DISCRETIONARY REVIEW ABBREVIATED ANALYSIS

HEARING DATE: February 18, 2021

Record No.: 2017-013728DRP-02
Project Address: 1021 Valencia Street
Permit Applications: 2020.0825.2609
Zoning: Valencia -NCT [Neighborhood Commercial Transit]
55-X Height and Bulk District
Mission Area Plan - Eastern Neighborhoods
Block/Lot: 3616 / 024
Project Sponsor: Ken Elkington
1641 Camino Verdera
Lincoln, CA 95648
Staff Contact: David Winslow – (628) 652-7335
david.winslow@sfgov.org

FLOOR 4-5 AND
FLOOR 6 PLAN

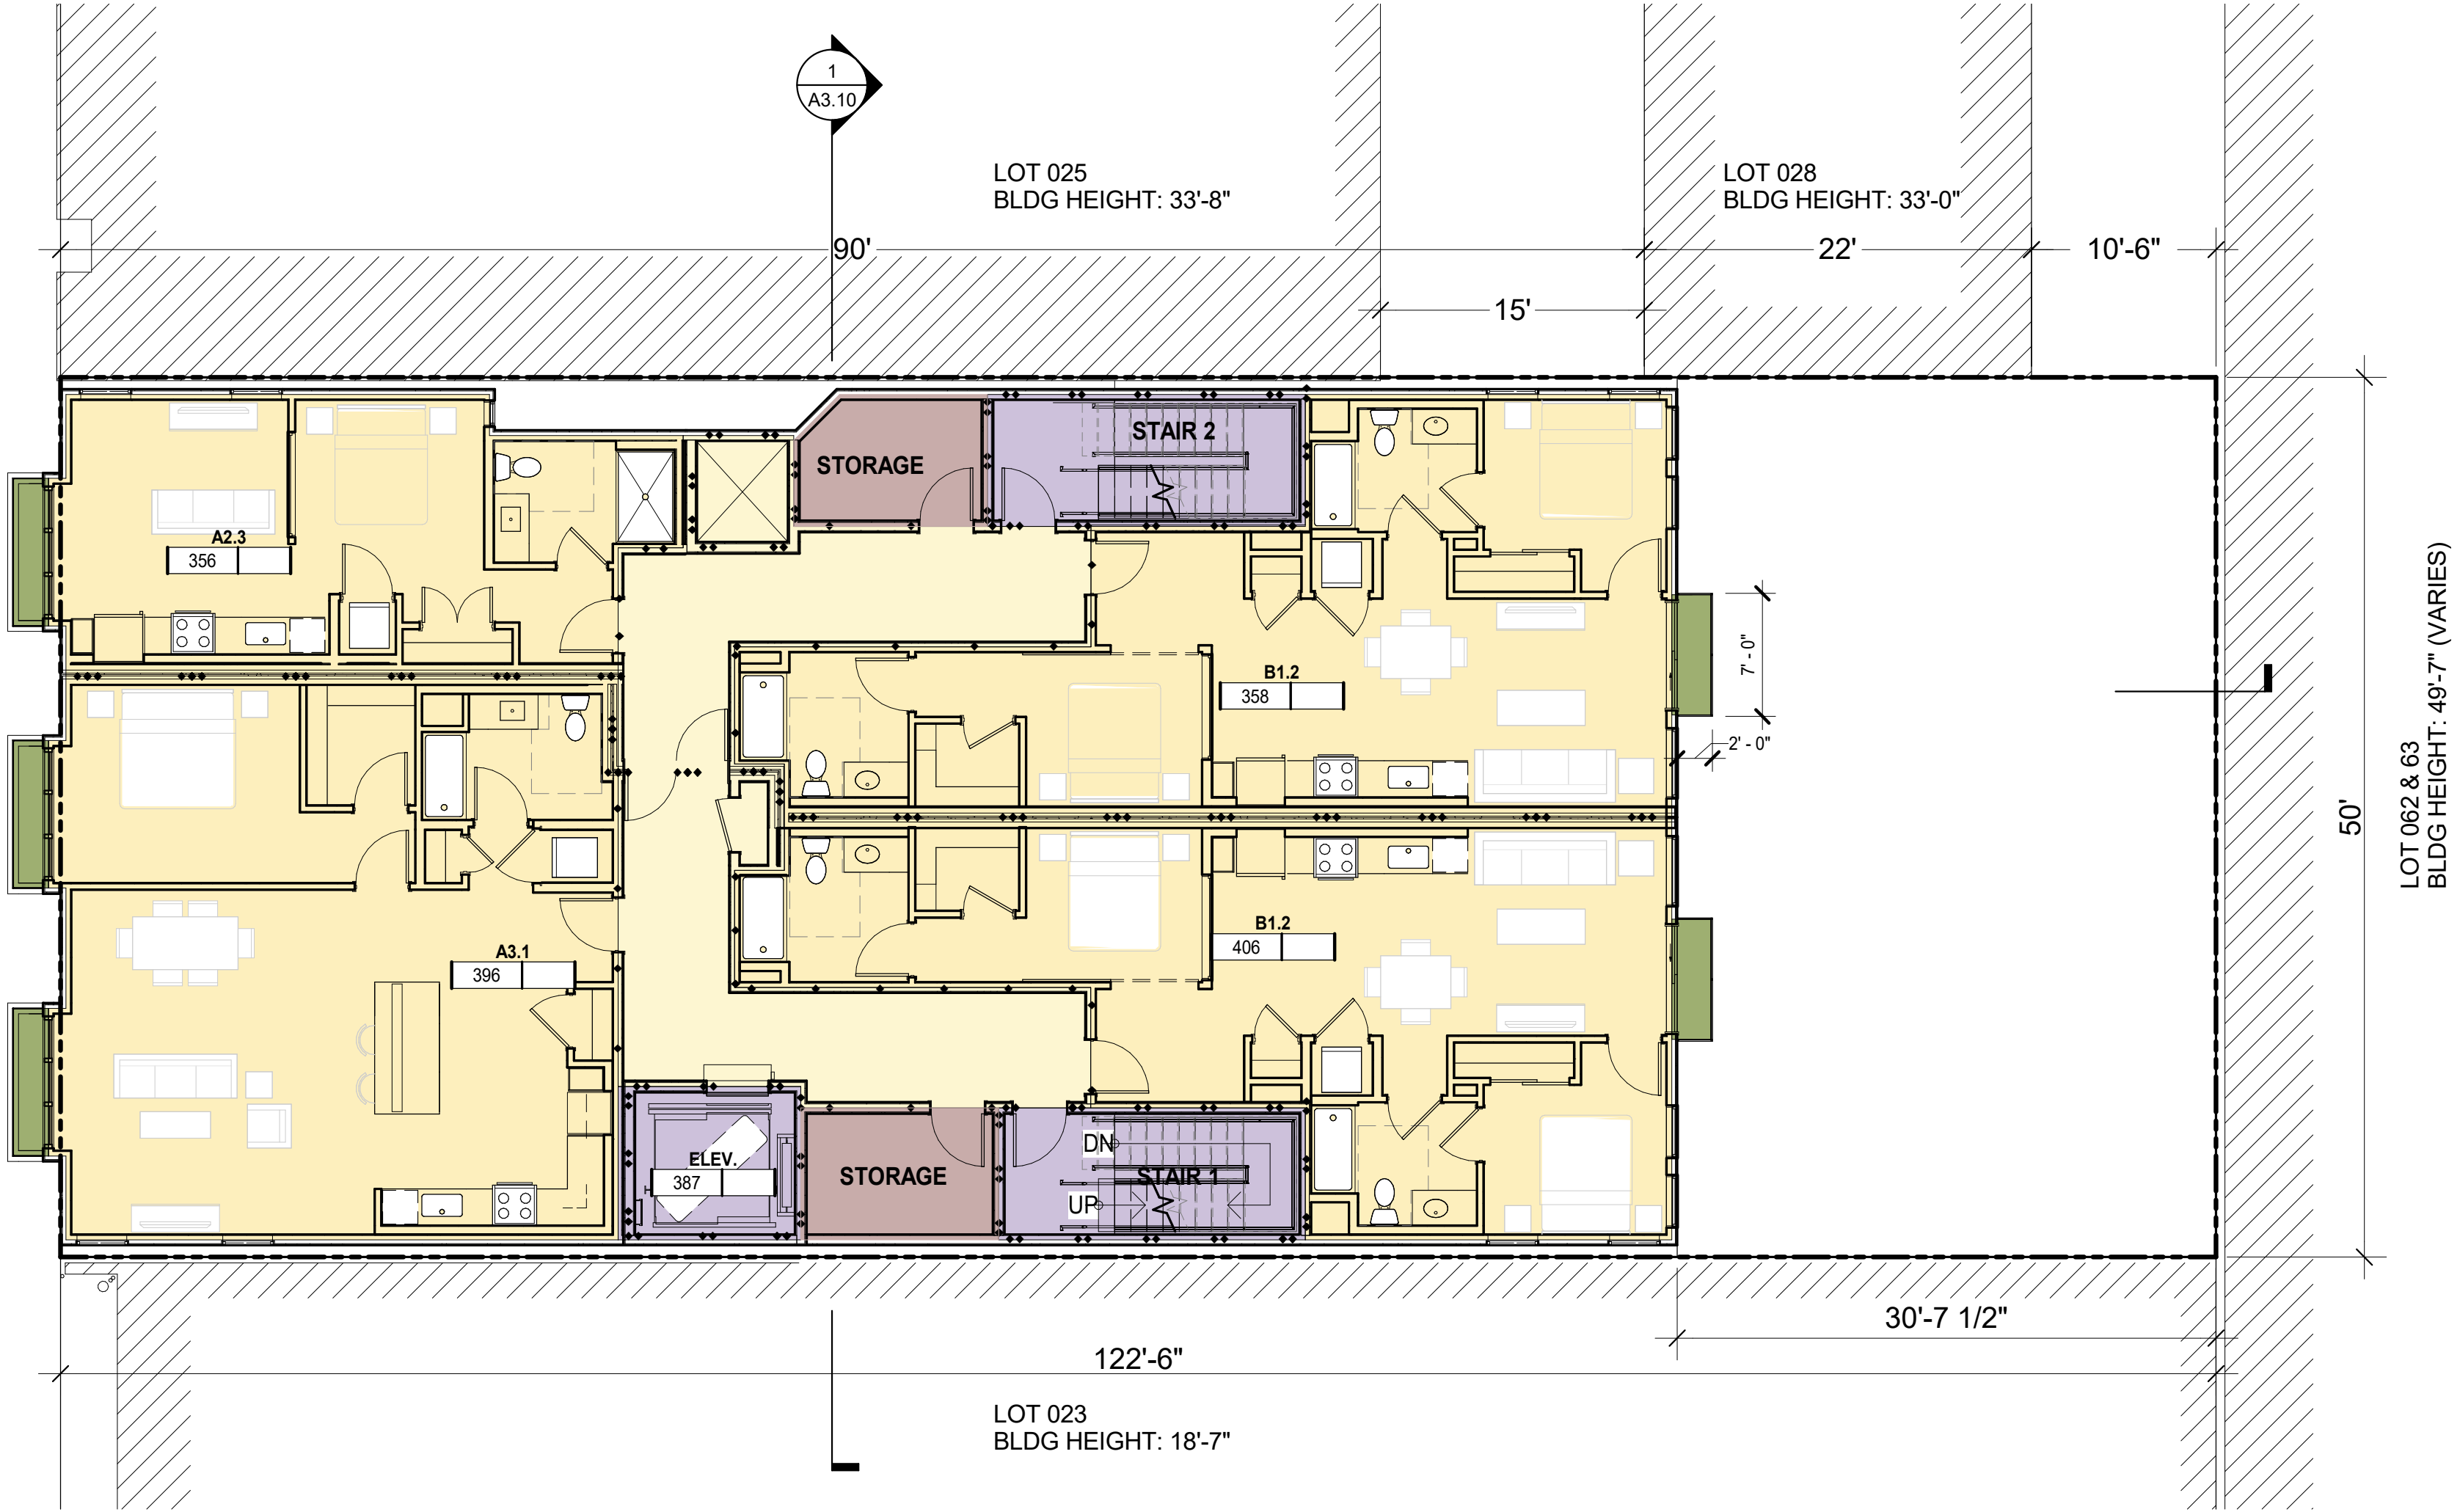
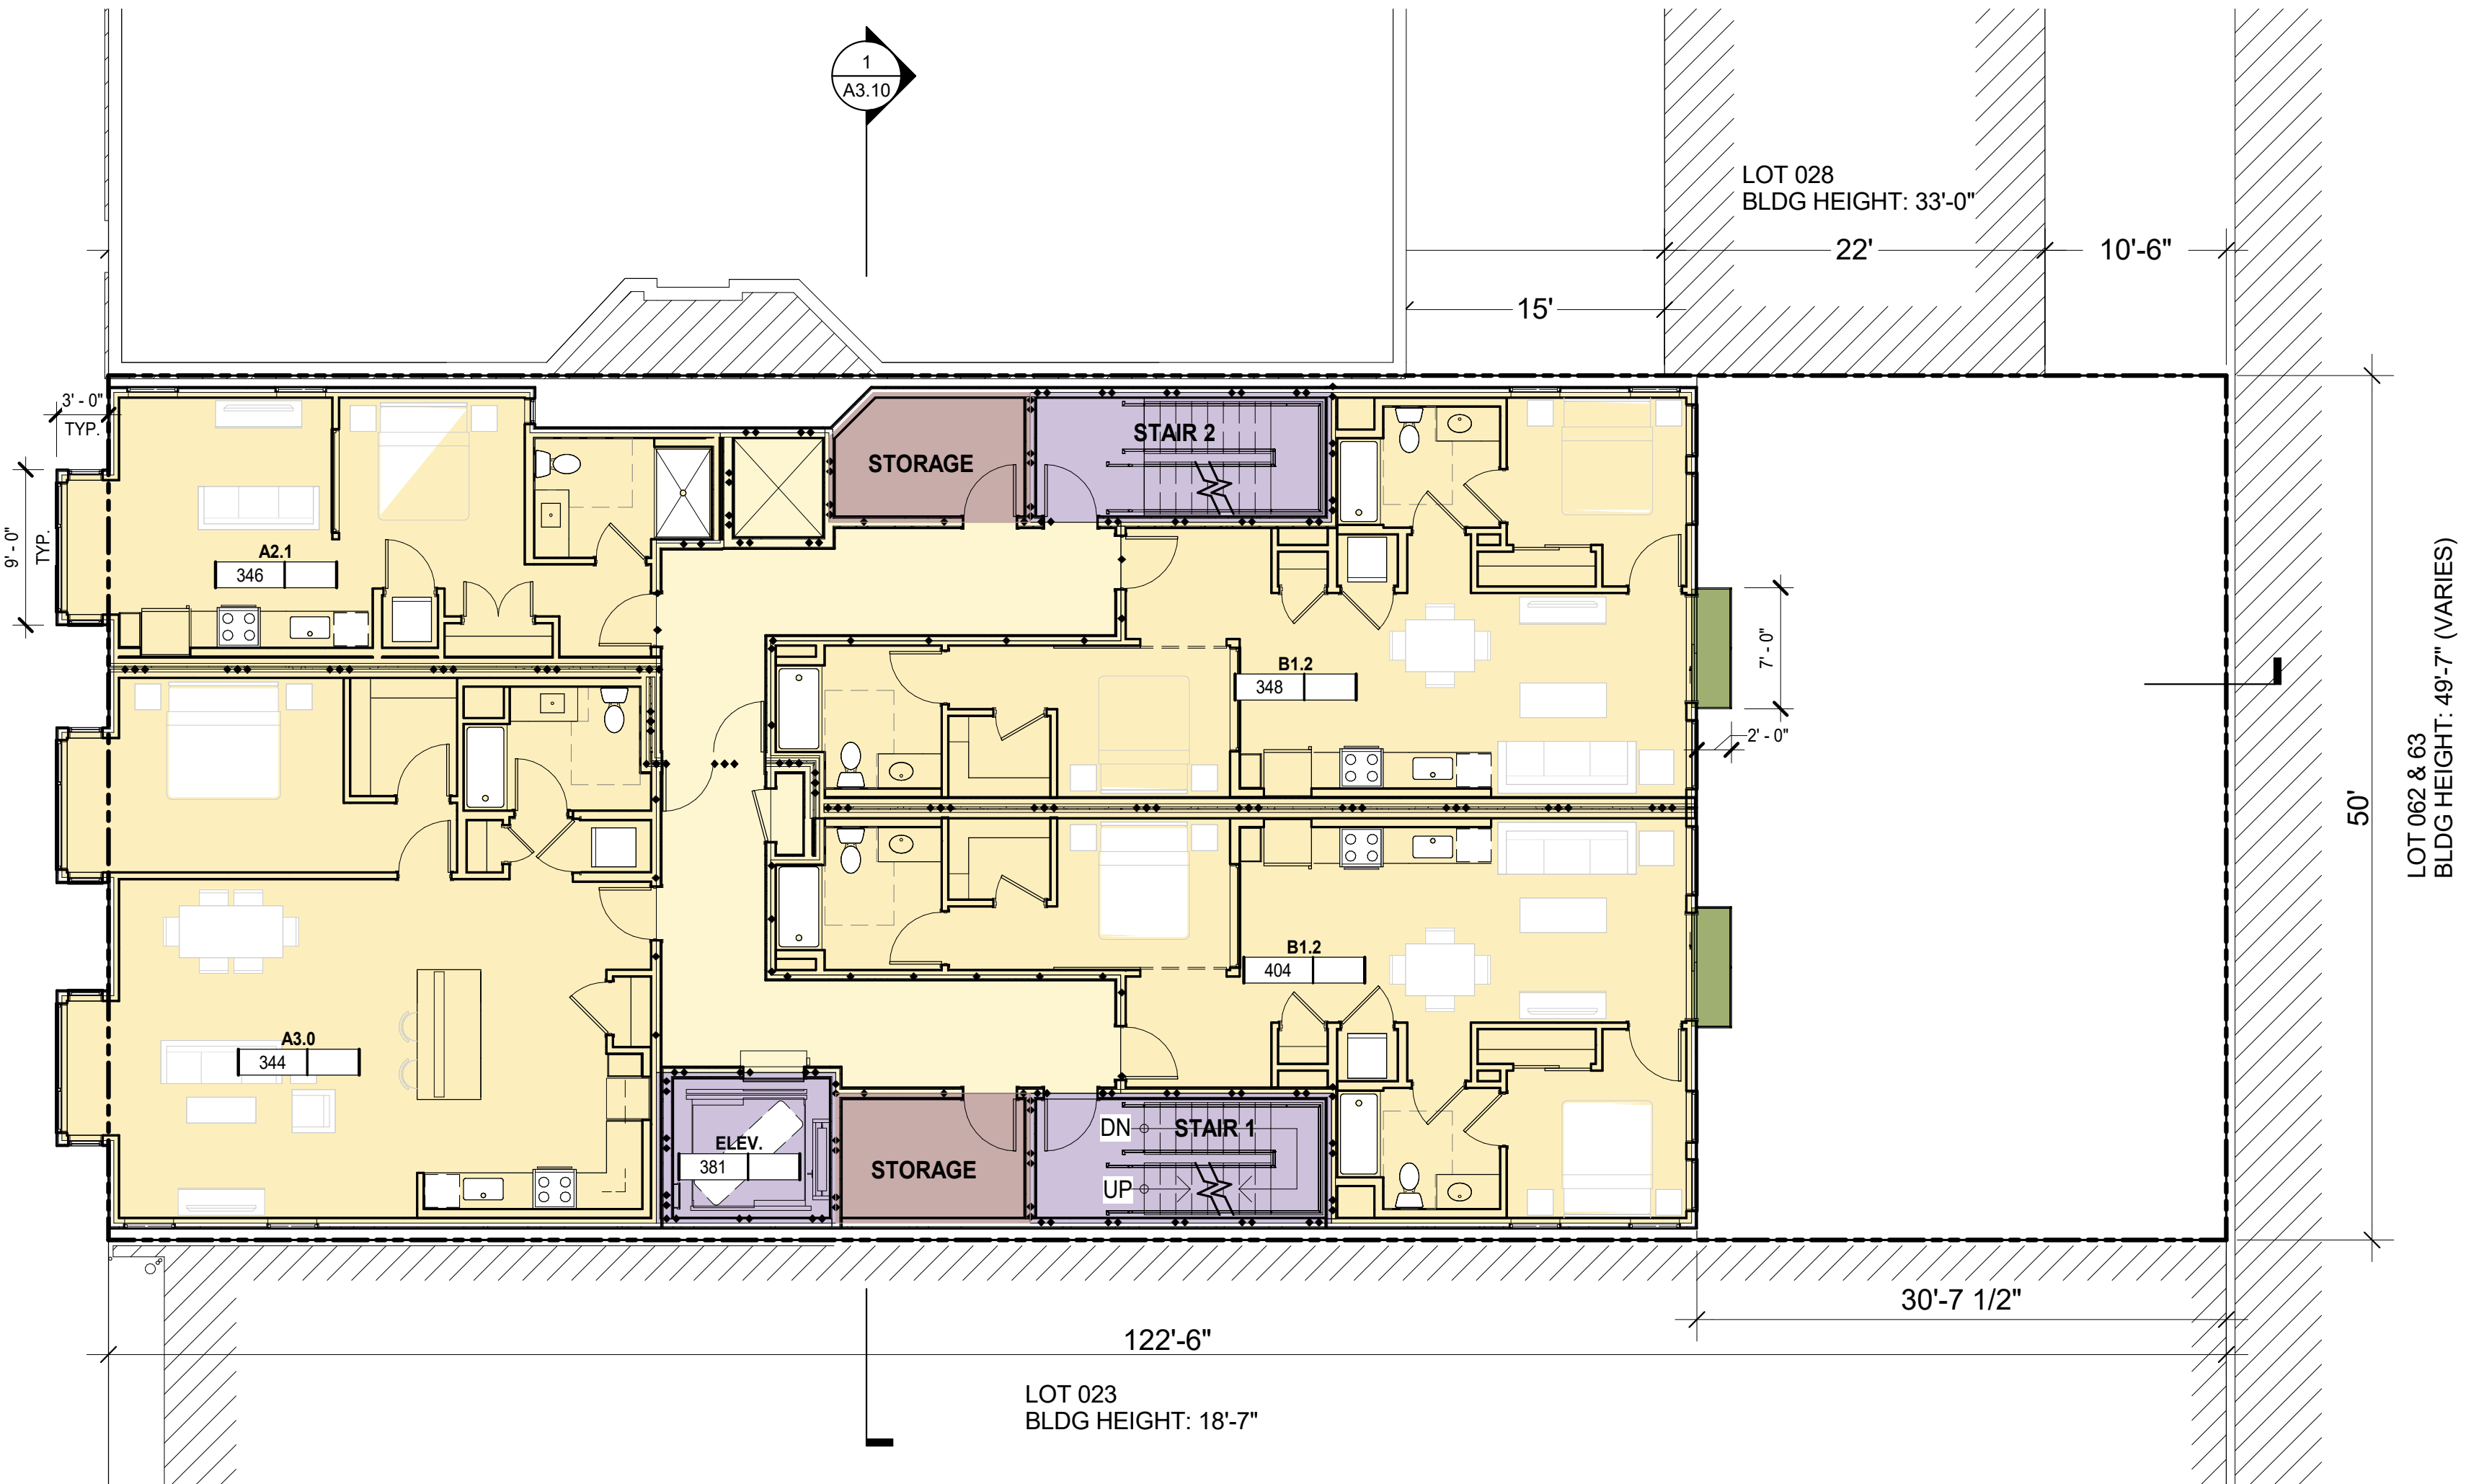
The Planning Department's review of this proposal confirms support for this Code-complying project. However, it is possible for the proposed project to better reciprocate with the adjacent building's rear yard and lightwell in a manner typically consistent with the Department's guidelines.

The State Density Bonus law allows a project to request concessions and waivers from the Planning Code. This project, as currently designed, is code -complying with respect to the rear yard. The project matches the adjacent building's light well with a light well that is 3' deep.

Planning staff suggested a modification of the building footprint at the rear which would give relief to the adjacent neighbors' rear yard by creating a 15' wide' x 8' deep reciprocating light well. This is achievable without losing any floor area or bedrooms by extending further into the rear yard to compensate for the floor area. Although, staff believes this would improve the access of direct light to the neighboring rear yard, the project sponsor was unwilling to make changes due to the increase in cost for the project. It is generally accepted that adding corners to a building does increase costs as does the cost of redesigning the building.

As such, the Planning Department is recommending approval as proposed.
